# UNITED STATES PATENT AND TRADEMARK OFFICE

10/538,515

<b>Office Action Summary</b>	<b>Application No.</b> 10/538,515	<b>Applicant(s)</b> WALDNER ET AL.	
	<b>Examiner</b> RACHEL T. YOUNG	<b>Art Unit</b> 3771

## **DETAILED ACTION**

**Fig. 8**

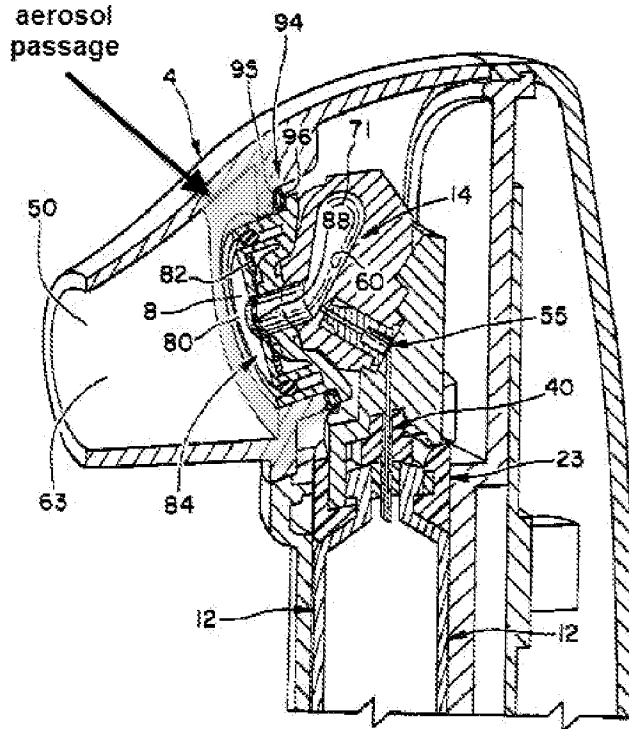
Regarding claim 1, in fig. 8 Patel discloses an inhalation therapy device comprising an aerosol membrane generator 2 having a liquid storage container 14 into which a liquid (Fig. 9) that can be used for therapy is fillable (Fig. 9), having a membrane 88 which is connected on one side with the liquid storage container such that a liquid disposed in the liquid storage container contacts one side of the membrane, and having an oscillation generator 8 for generating oscillations by means of which a liquid disposed in the liquid storage container is nebulised (Col. 2, ll. 45-50, Col. 4, ll.

66-67-Col. 5, ll. 1-9) into an aerosol through openings (90, Fig. 7) in the membrane (88, Col. 5, ll. 3-9) to the other side of the membrane, a mixing chamber 63 into which the aerosol membrane generator generates the aerosol, having an aerosol passage (see Fig. 8 below), via which the aerosol generated by the membrane generator arrives in the mixing chamber (Col. 4, ll. 62-65), the aerosol passage being disposed with one section on a surface of the aerosol membrane generator so as to surround the membrane along at least one sealing line (Col. 5, ll. 28-29) and extending in an opening manner into the mixing chamber, having at least one breathing air through opening 10 disposed in the region around the aerosol passage (Fig. 1). Patel discloses an aerosol passage and a breathing air through opening, but is silent regarding an inhalation valve disposed in the region around the aerosol passage that opens the breathing air through opening during inhalation and closes the breathing air through opening during exhalation. However, Denyer teaches an inhalation valve (Fig. 2, 94 Fig. 11) disposed in the region around the aerosol passage (Fig. 2) that opens a breathing air through opening (Fig. 2) during inhalation and closes the breathing air through opening during exhalation (Col. 10, ll. 61-63). Therefore, it would have been obvious to one of ordinary skill in the art at the time the invention was made to substitute Patel's region around the aerosol passage with an inhalation valve and breathing air through opening disposed in the region around the aerosol passage that opens a breathing air through opening during inhalation and closes a breathing air through opening during exhalation, as taught by Denyer, for the purpose of entraining air only during inhalation to protect the

Regarding claim 5, the modified Patel's nebulizer discloses that the aerosol passage is pipe-shaped (see Fig. 8 above) and the valve element is annular (Denyer, Fig. 2, Patel Fig. 1) and the valve element accommodates the pipe-shaped aerosol passage in the annular opening (Denyer, Fig. 2, Patel Fig. 1).

Regarding claim 7, the modified Patel's nebulizer discloses a pipe-shaped aerosol passage that is formed by a cylindrical sleeve (walls of aerosol passage in Fig. 8 above), provided on the outer surface of which is a region (Denyer, 3 Fig. 2, Patel Fig. 1) accommodating the breathing air through openings (Denyer, Fig. 2, Patel Fig. 1), which extends essentially perpendicular to the longitudinal axis of the sleeve (Denyer, Fig. 2, Patel Fig. 1).

Regarding claim 8, the modified Patel's nebulizer discloses that the cylindrical sleeve is disposed concentrically to the membrane (see Fig. 8 above).

Regarding claim 10, the modified Patel's nebulizer discloses that the aerosol passage comprises a bulge (Patel, 84, Fig. 8) in the area facing the membrane.
